Sustainability and Climate Change

Climate Change Mitigation and Adaptation

This chapter addresses comments related to solar heat gain mitigation, central air source heat pumps, stormwater management, emergency power, heat island mitigation, and sea level rise resilience.

Chart 3-1 Effect of SHGC on HVAC electricity usage for four orientations of a typical one-bedroom apartment.

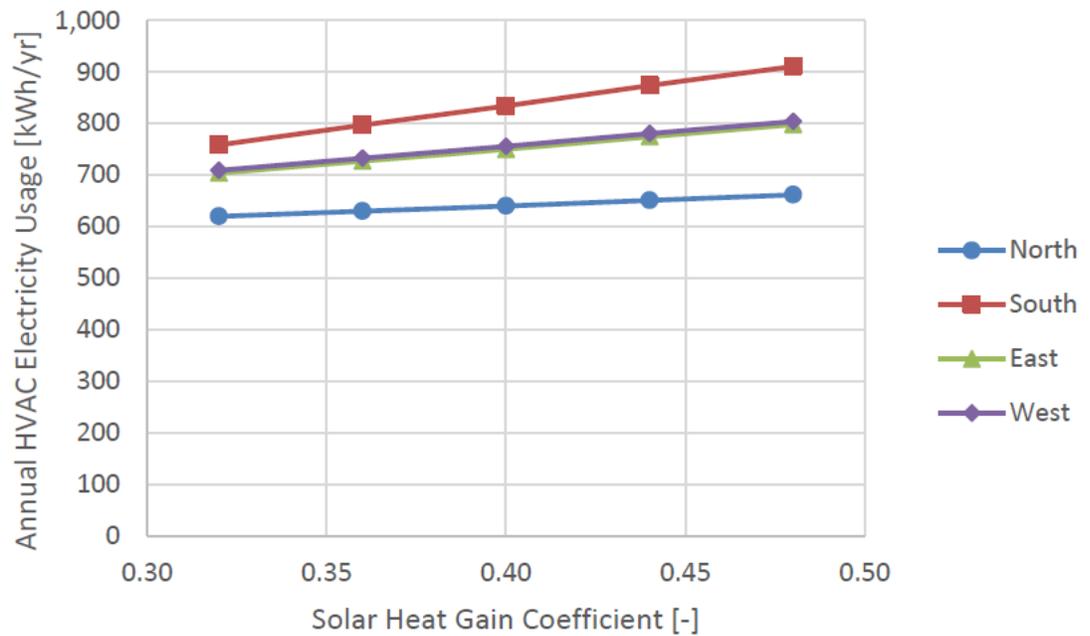
3.1 Solar Heat Gain Mitigation

The effect of SHGC on annual HVAC electricity usage for a representative 1-bedroom apartment is presented in Chart 3-1 below for whole-window SHGCs ranging from 0.32 to 0.48. This range of SHGC is typical for Boston. Results are presented for north, south, east, and west-facing apartment orientations. Note that the energy usage presented is only the energy used for heating, cooling, and ventilation, and does not include other building energy uses.

For all four orientations, as SHGC decreases, energy use decreases. South-facing apartments have the greatest energy use, whereas north-facing apartments have the least. The effect of lowering SHGC is most pronounced for south-facing apartments and least pronounced for north-facing apartments. East and west-facing apartments have similar energy usage. The effect of SHGC on energy usage is also similar for east and west-facing apartments.

Reducing solar gains reduces cooling demand and total energy usage for all apartment orientations. The percent reduction in HVAC electricity usage, corresponding to a reduction in SHGC from 0.48 to 0.32, ranges from 6 percent for north-facing apartments to 16 percent for south-facing apartments. It is therefore recommended to use low SHGC windows on all building facades. A whole-window SHGC of 0.32 is a good target value that may be applied consistently across all facades. The results of the SHGC study are consistent with cooling demand being a driving factor in the design of multifamily Passive Houses in this climate.
